Subject: Response to NRC's Request for Sensitivity Studies Regarding Appendix A of Topical Report (TR) WCAP-16608-P, "Westinghouse Containment Analysis Methodology" (TAC No. MD2953) (Non-proprietary)

**Response to NRC's Request for Sensitivity Studies  
Regarding Appendix A of Topical Report (TR) WCAP-  
16608-P, "Westinghouse Containment Analysis  
Methodology"  
(TAC No. MD2953) (Non-Proprietary)**

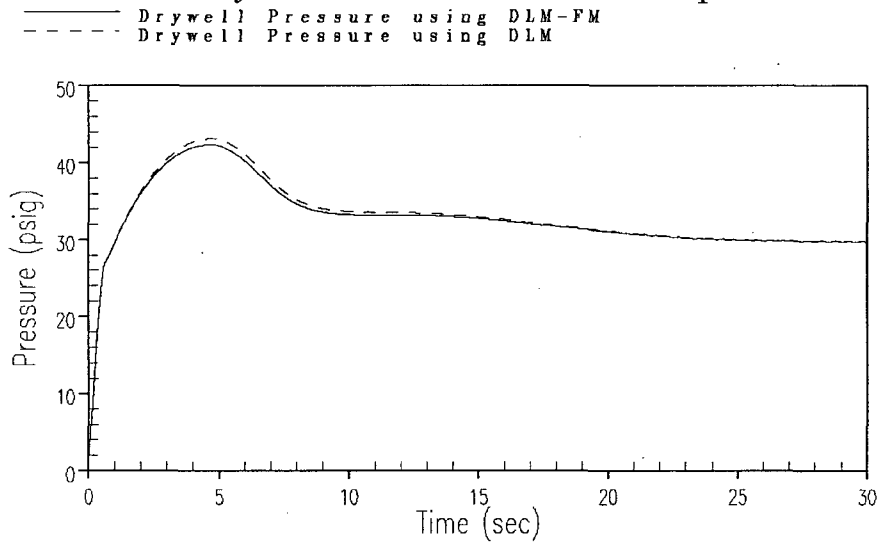
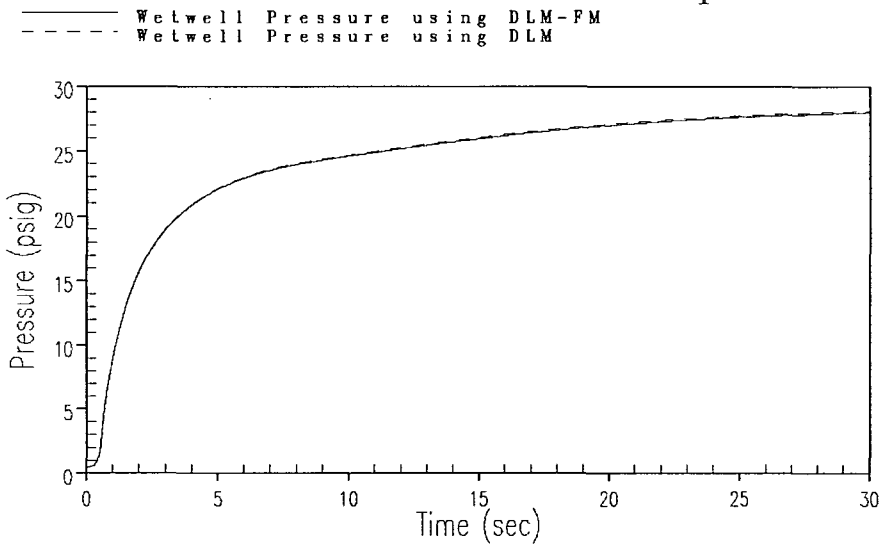
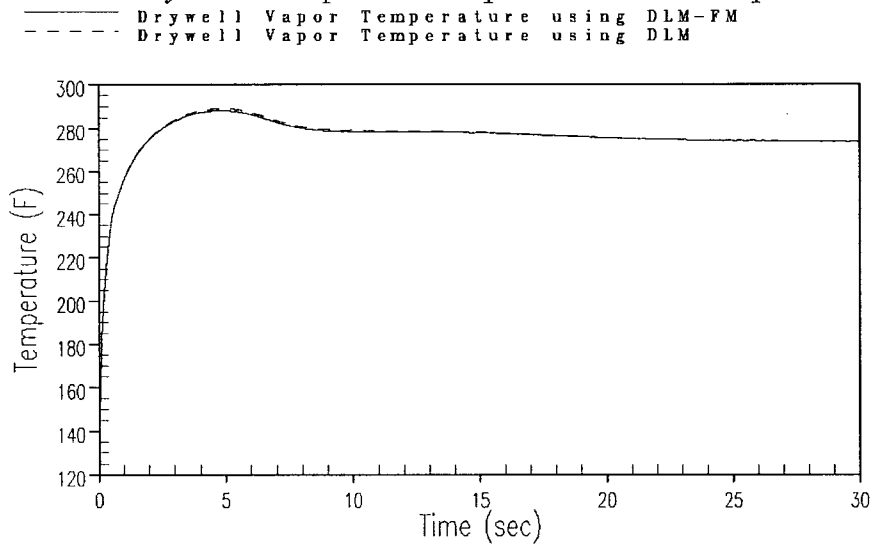
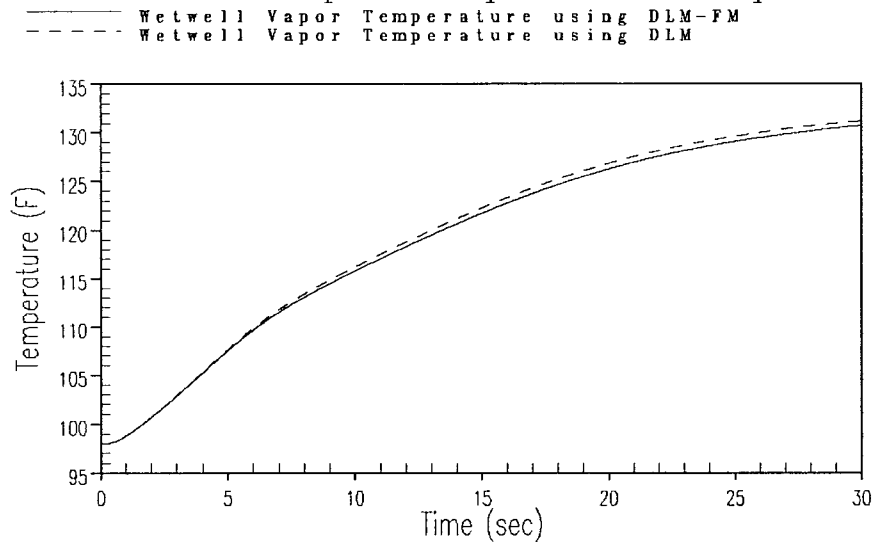
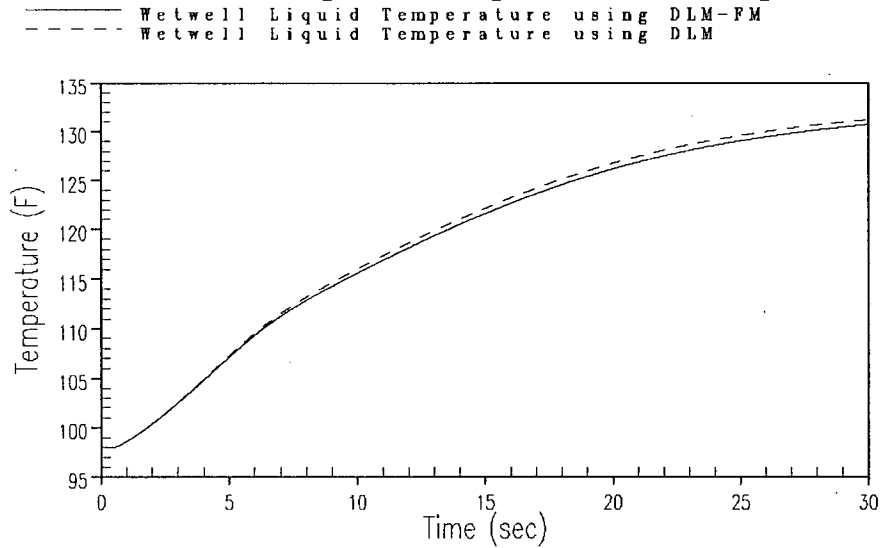
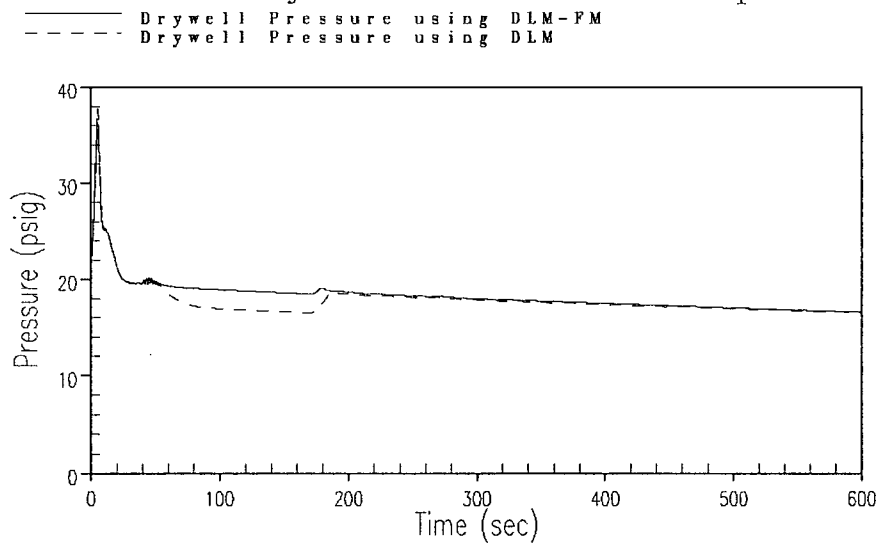
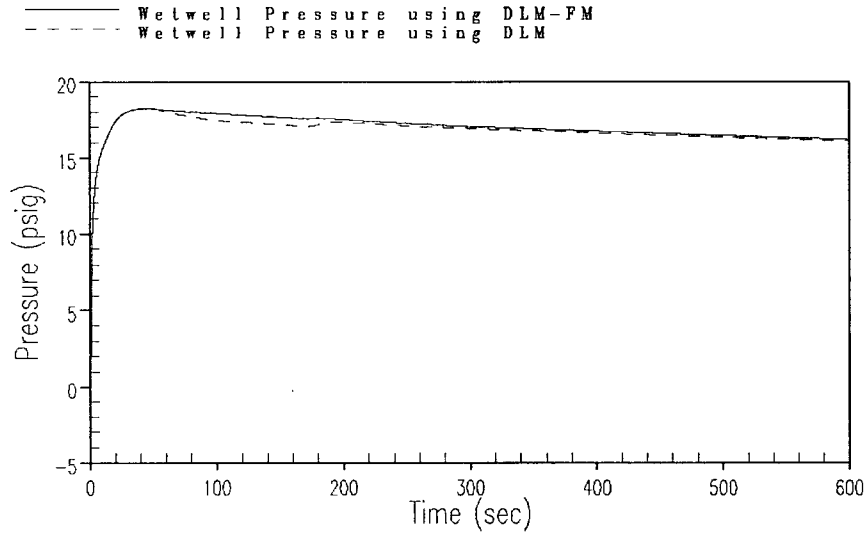
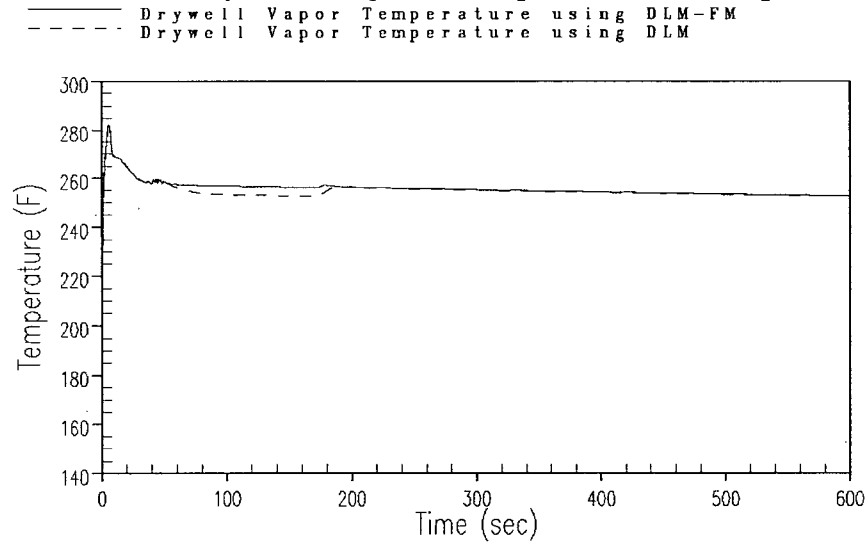
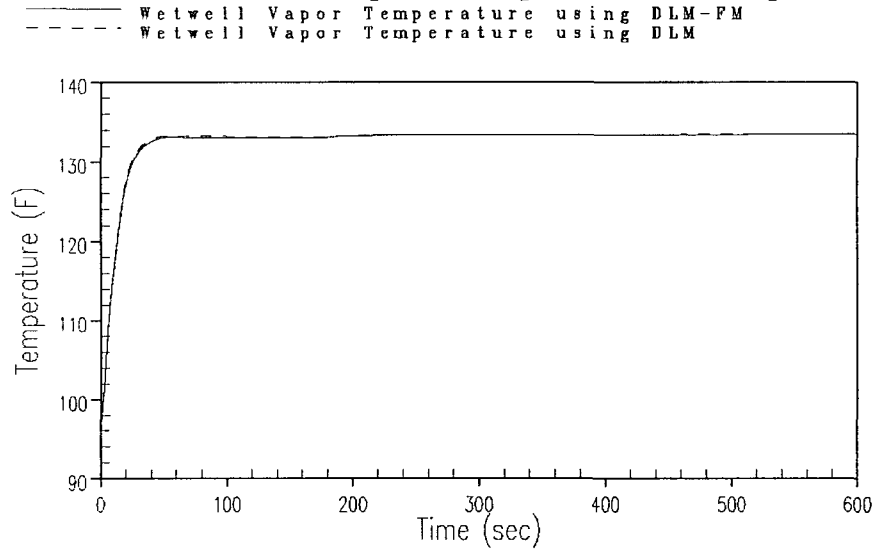
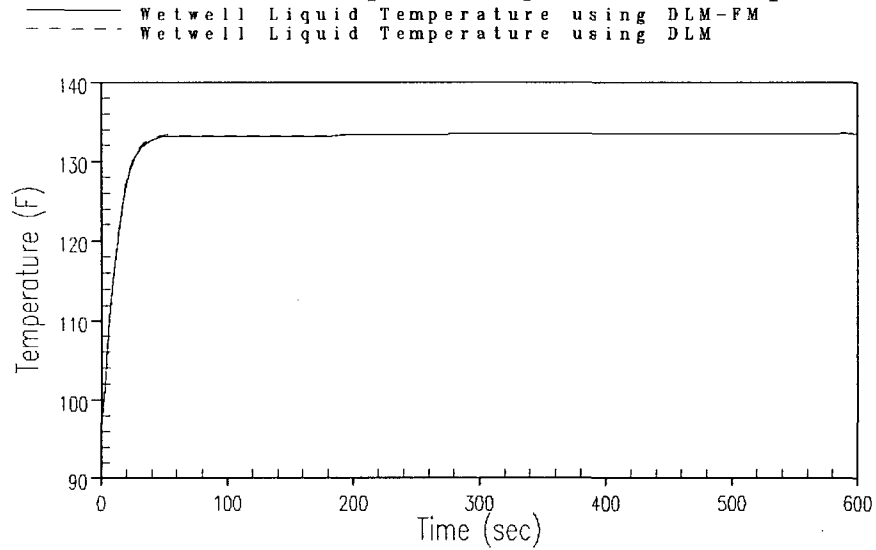
As part of their acceptance review for WCAP-16608, Appendix A, the NRC asked Westinghouse to determine the sensitivity to the condensation heat and mass transfer option with the generic GOTHIC BWR Mark I containment model. The sensitivity cases were run using the RSLB peak pressure and ECCS minimum backpressure models. The condensation heat and mass transfer option in each model was changed from DLM to DLM-FM for the sensitivity case.

Plots comparing the containment pressure, temperature, and suppression pool temperature responses with the two options are contained in the following pages. The model results are not very sensitive to the condensation heat and mass transfer option. We use the DLM option since it had been previously accepted by the NRC for PWR containment analyses.
